**AMENDMENTS TO THE DRAWINGS**

## REMARKS

FIG. 6

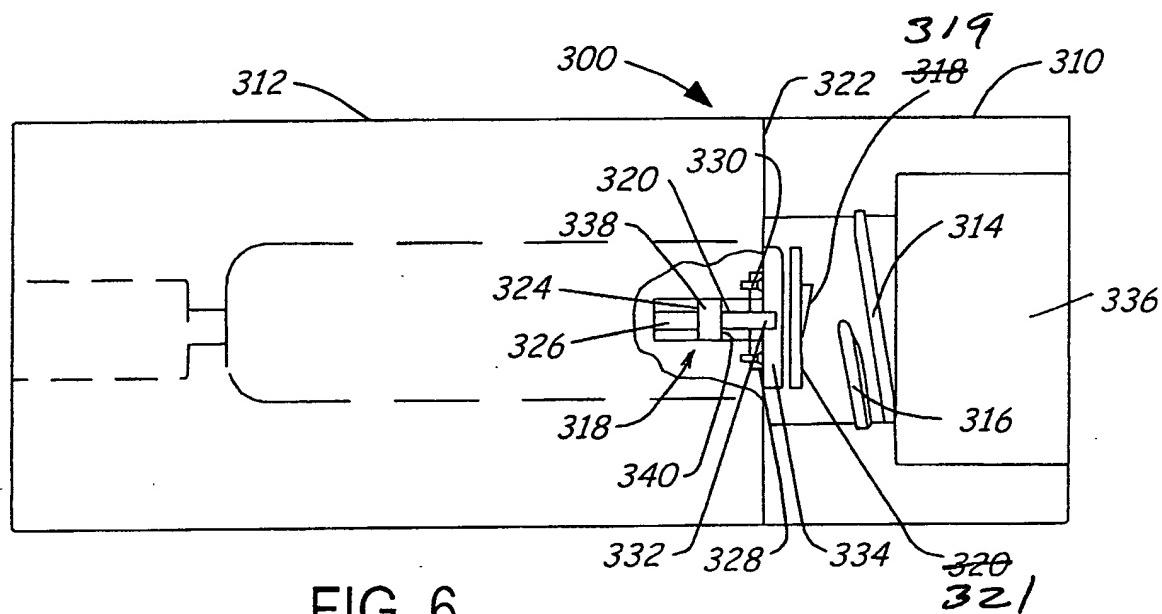
FIGS. 6 and 7 of the drawings have been amended to correct the duplication of reference numerals 318,320 in the drawings as filed. Corresponding corrections have been made at page 11 of the application text.

Replace the drawing sheet containing FIGS. 5-7 with the enclosed Replacement Sheet containing FIGS. 5-7. An Annotated Marked-up Drawing of FIGS. 5-7 accompanies this Amendment showing reference numeral corrections in FIGS. 6 and 7.
